ARCHITECTURAL REVIEW BOARD MUNICIPAL PLANNING COMMISSION -AGENDA-Thursday, November 9, 2023 at 7:00 P.M.

MEMORANDUM

SUBJECT: Staff Memo for the Meeting of November 9, 2023

CITY OF WORTHINGTON **DRAWING NO. CU 04-2023** SUB 04-2023 DATE 10/24/2023

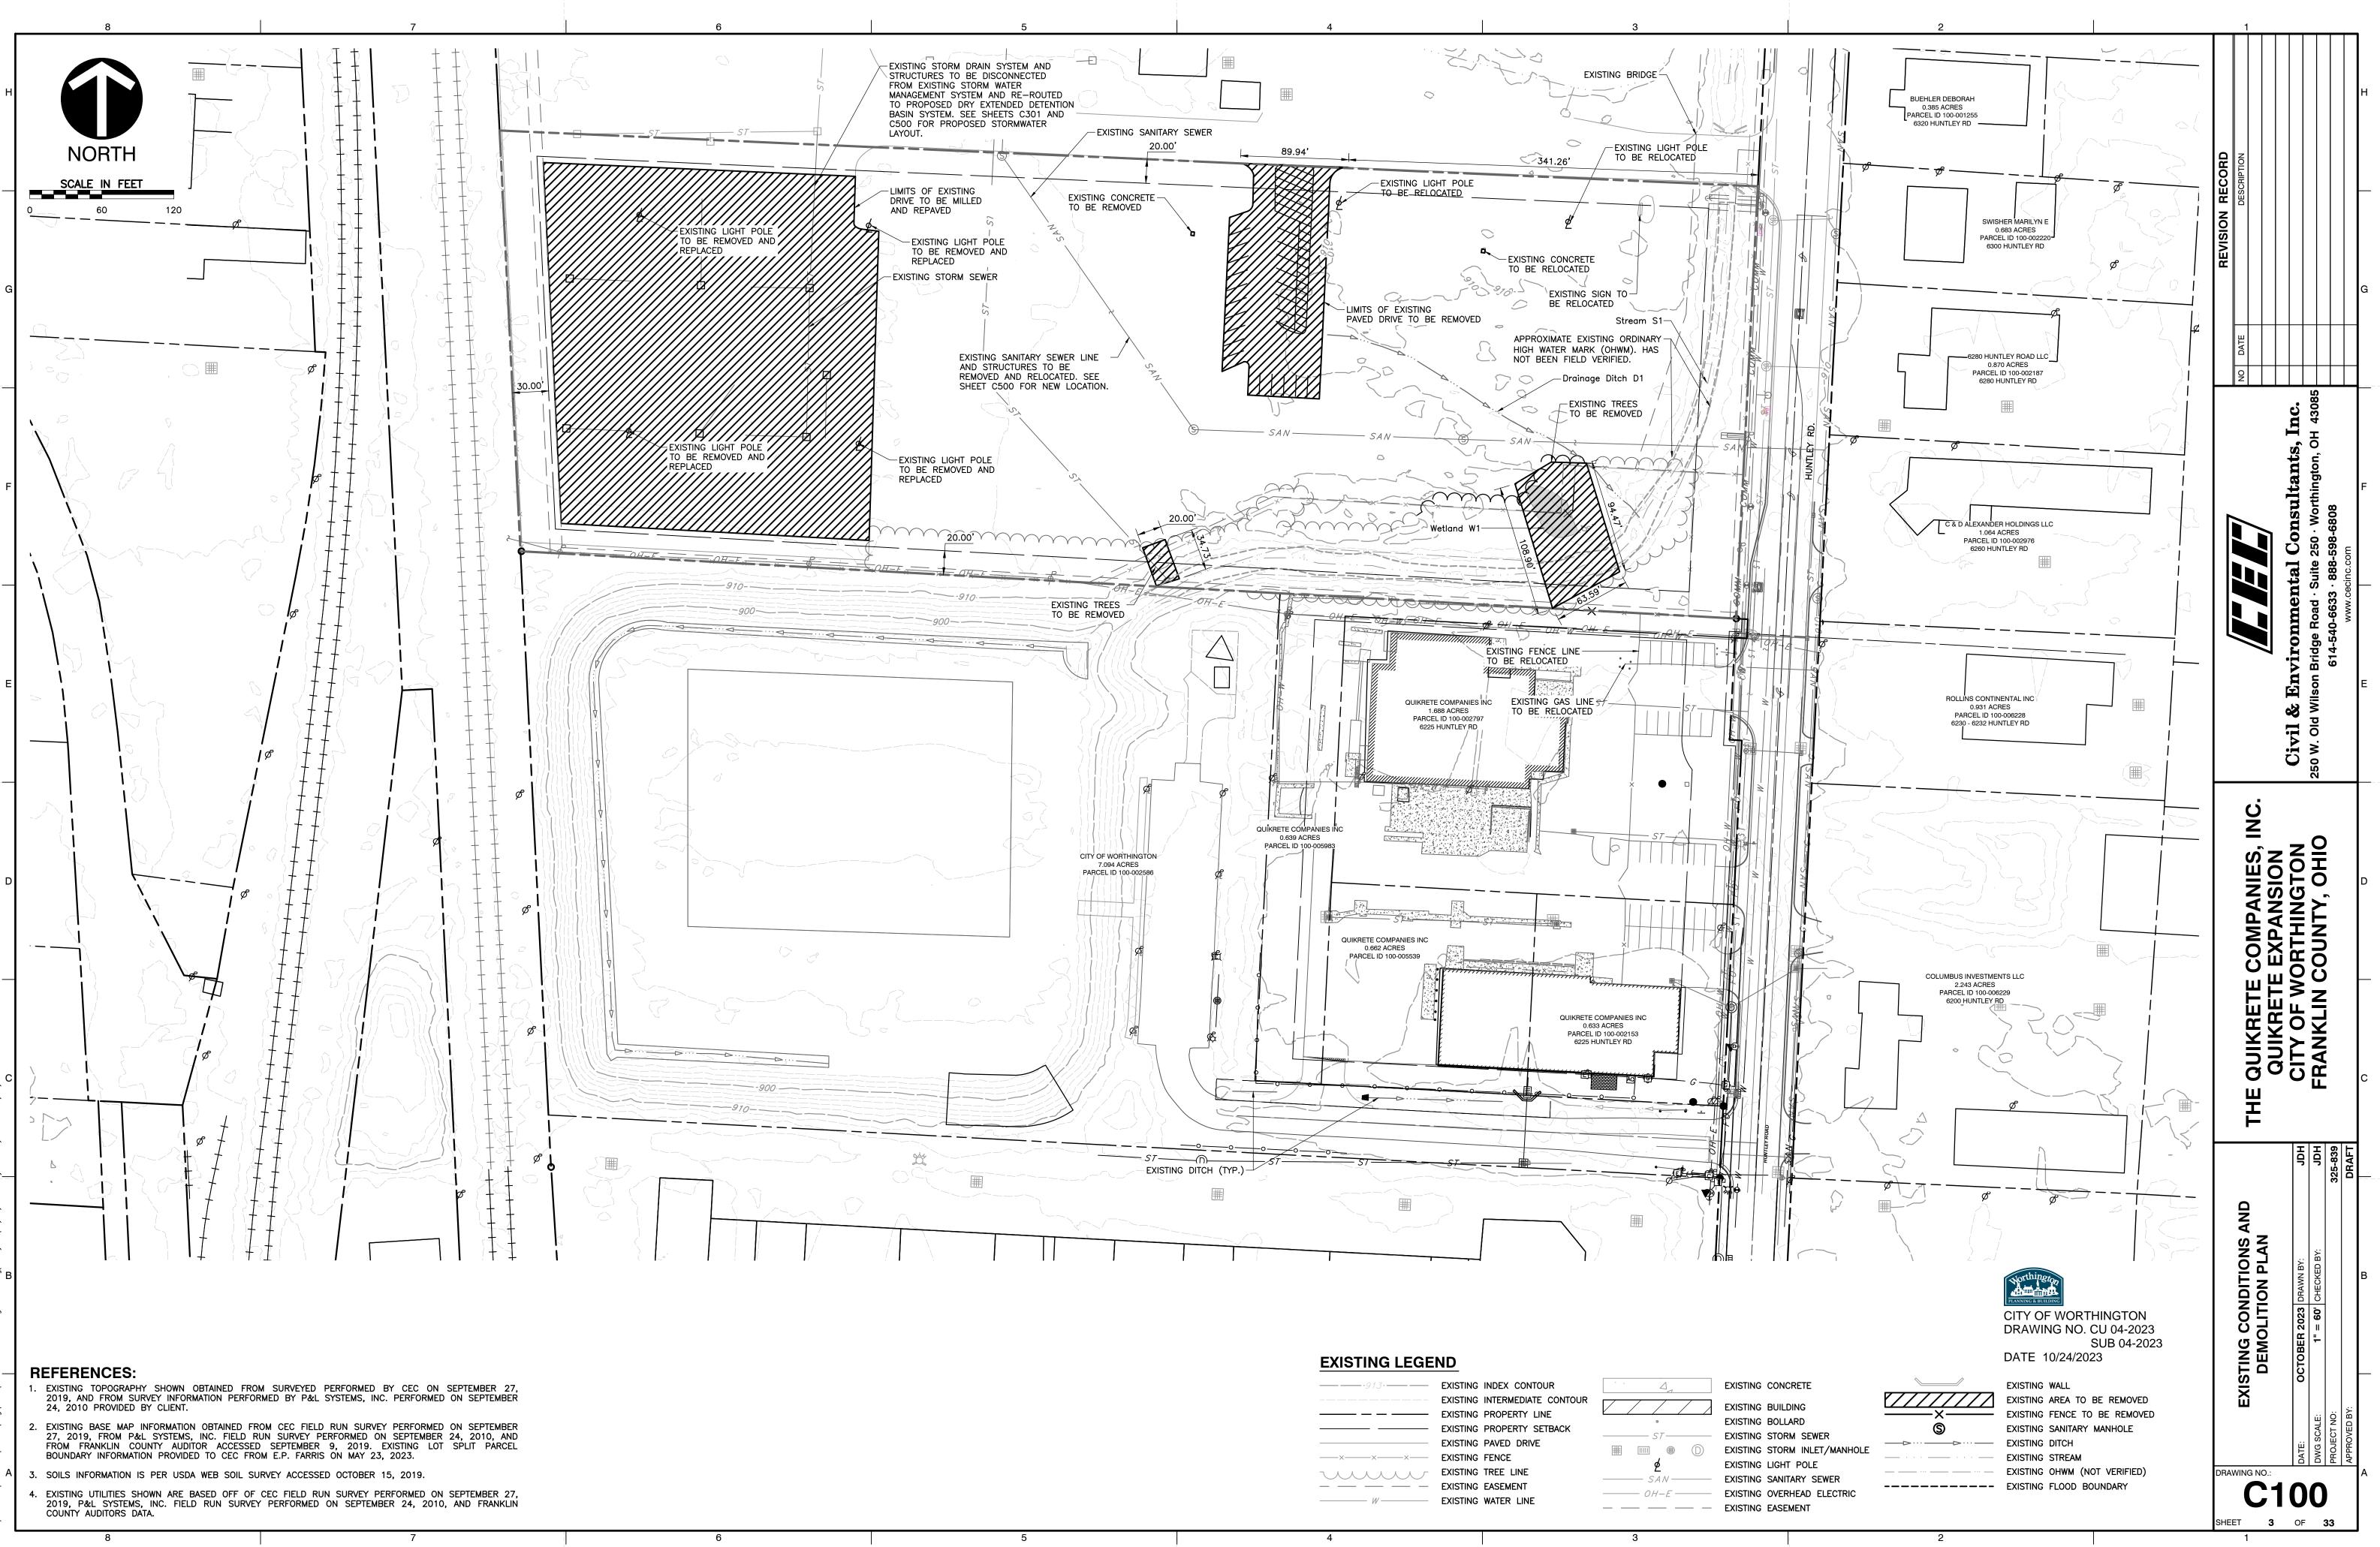
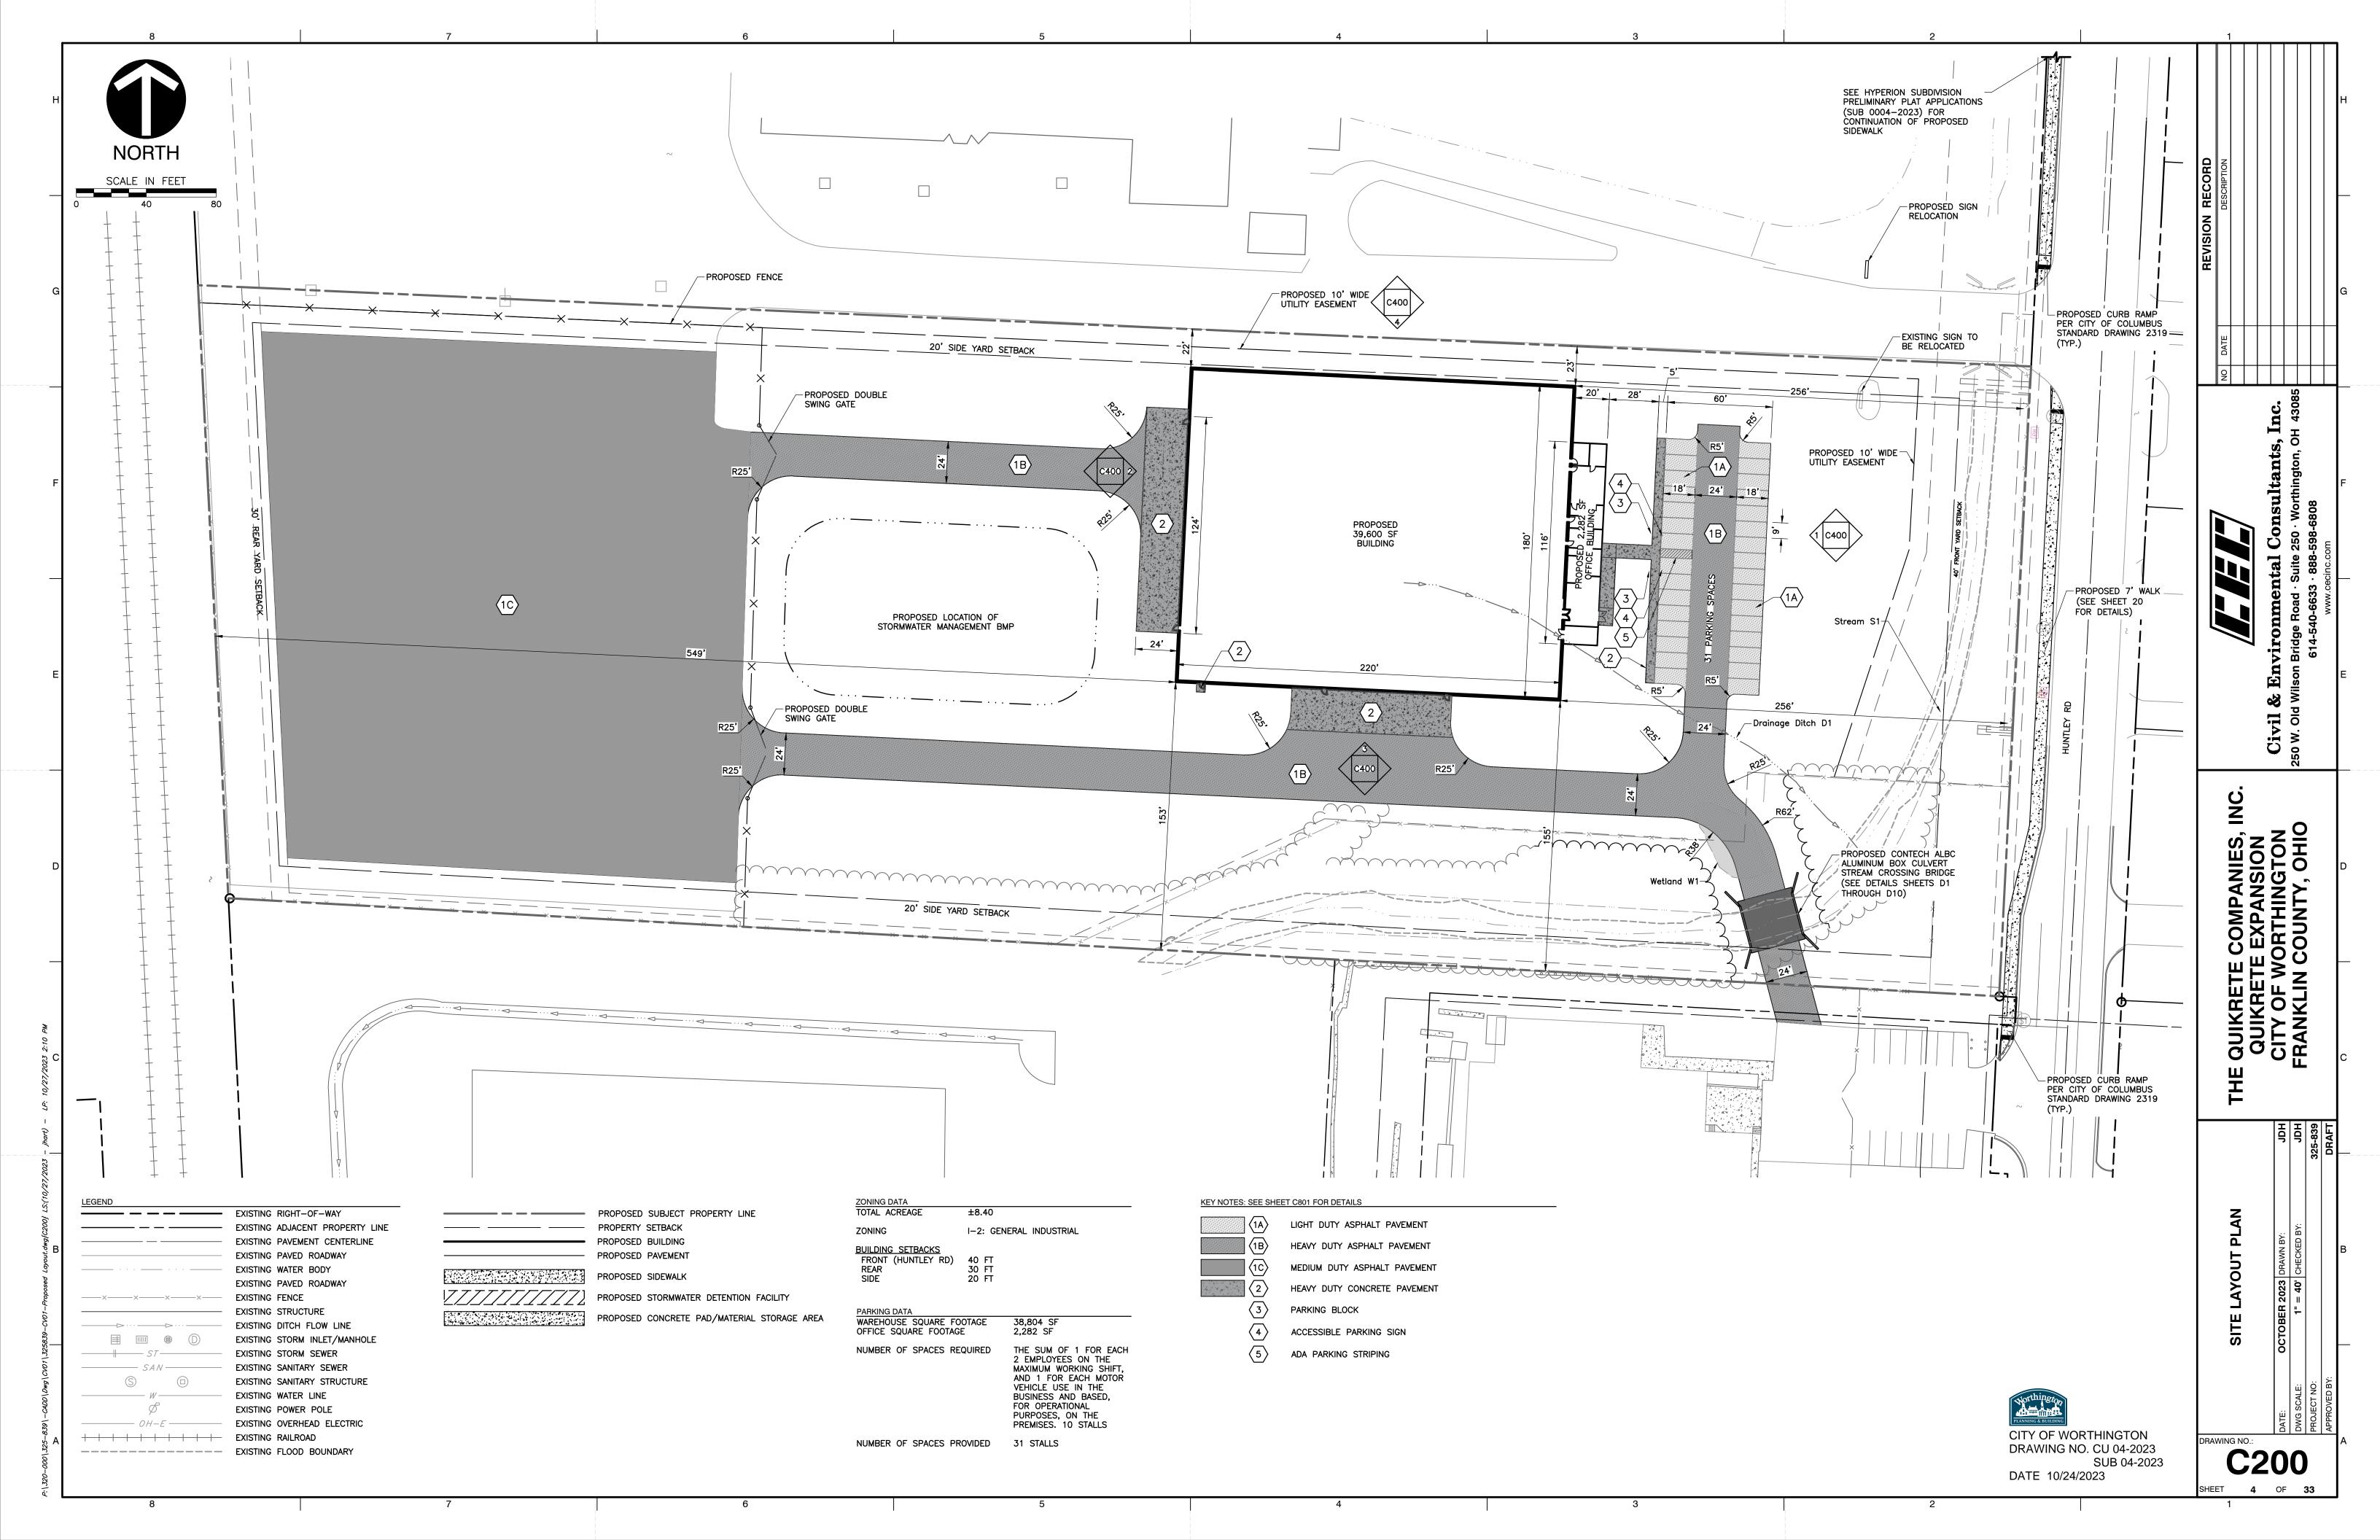
- Verify current R/W locations, specifically as it relates to existing fence location along the proposed subdivision.
- 3. Stormwater Management/Drainage

- A stand-alone SWP3 will be ultimately required as well as Post Construction Stormwater Operation & Maintenance plan.
- 4. <u>Parking</u>
 - 2 ADA parking spots shall be required with a minimum of one space being van accessible. This is not shown.

- Show the installation of sidewalk along the entirety of the parent parcel and remainder parcel subject to this subdivision.

- The site plan provided indicates a roadway to the adjacent property to the south. No specific use group information per <u>OBC Chapter 3</u> was found and is likely S-1 per <u>OBC 311.2</u>. The proposed utilities to the new building indicates only a single water line, assumed to be for domestic water needs. <u>OBC 903.2.9</u> will likely require a fire suppression system in the building unless the fire areas within the building can be kept to under 12,000 sf using fire barriers in <u>OBC Section 707</u>. However, if storage exceeds 12', then fire suppression may be required per <u>OBC 413.1</u> and <u>OFC Chapter 32</u>. <u>OBC 1028.5</u> requires the exit discharge of a building to provide a direct and unobstructed access to the public way. No such pathway was found.

- Some variety in the proposed landscaping may be appropriate.
- 2. Building
 - More details of the building are needed.
- 3. Employees
 - Based on the Comprehensive Plan, this corridor should be an employment center. Staff believes a larger number of employees should be on the proposed acreage.
